May 29, 2007

Subject: Bacteria-1 and Chollas Creek Dissolved Metals TMDLs

Canyon Mouth Option

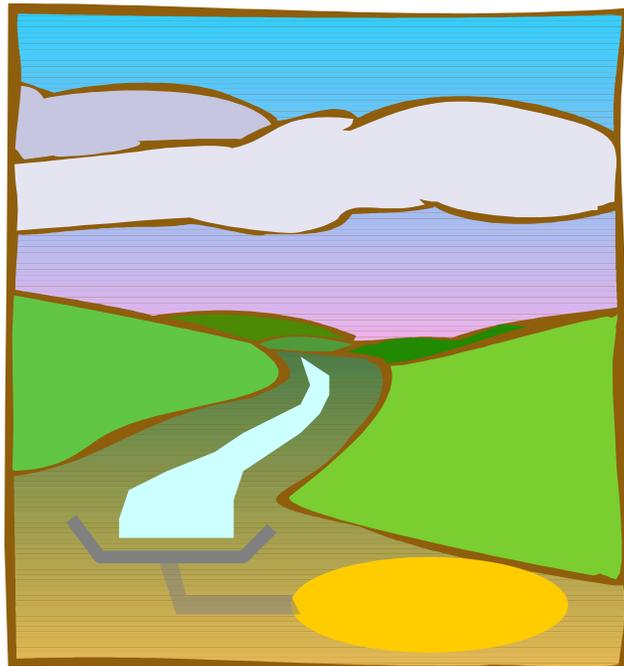
I have recently been invited by Regional Board staff to submit a proposal for what kind of BMP the City would like to build below outfalls. In response, I submitted the attached graphics and was told by Regional Board staff that these proposals were, in concept, acceptable, at least in terms of allowing receiving waters/Waters of the State to convey waste and in terms of achieving Wasteload Allocations below storm drain outfalls and still complying with the TMDLs. Please acknowledge that these solutions are conceptually acceptable. Based on a quick analysis, these solutions might be available for approximately 480 of the 800 outfalls within Chollas Creek.
